Subject: Class II permissive change Request

FCC ID: 2APKV-518912

Pursuant to CRF Section 2.1043, Aduro Technologies LLC requests a Class II permissive change to update the filing. All of the changes are not effect to the RF performance, function and power.

Original: 81812-V2

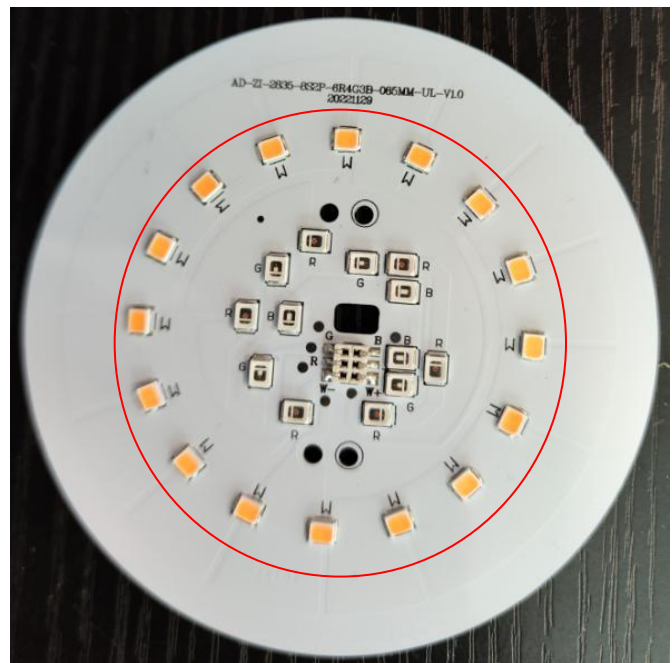
1. Different shapes ;
2. LED PCB different sizes ; 81812-V2: Ø39mm
 81813-V2: Ø85mm
3. LED emit different colors ; 81812-V2: 2700K+6500K
 81813-V2: 2700K+R+G+B
4. LED different amount ; 81812-V2: 12+12
 81813-V2: 12+6+4+3
5. LED PCB different layout ;
6. Drive PCB different layout ;
7. Drive PCB different sizes ; 81812-V2: 45.5*31.5mm
 81813-V2: 45.5*34.0mm
8. Different power ; 81812-V2: 8.5W
 81813-V2: 10W
9. Change product name and model number
